# Mischief in the Making

The Canadian Nuclear Safety Commission

The Darlington New Nuclear Project (DNNP)

November 20, 2023

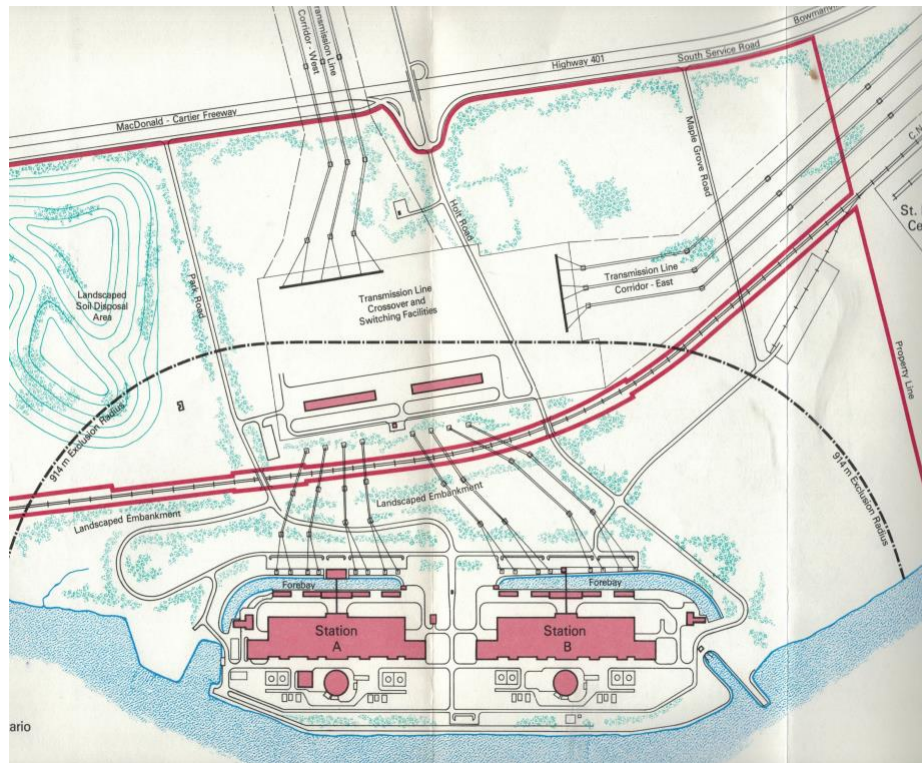
- The BWRX-300 reactor design is unlike any other reactor considered by the JRP in that the entire reactor core together with all of its reactivity control mechanisms are below ground level, in a cylindrical space whose outer walls are submerged in water. [see diagram]

- This cylindrical configuration, which extends 38 metres below ground, containing almost the entire radioactive inventory of the BWRX-300 design, is equivalent to a 10 to 12 storey building where the different floors go deeper and deeper down. Subterranean features related to groundwater, seismicity, and soil characteristics such as potential for liquefaction, as well as the potential impacts from explosive blasts, all require a very different and more nuanced analysis for such a reactor than would be required for an above-ground reactor. The configuration is fundamentally different.
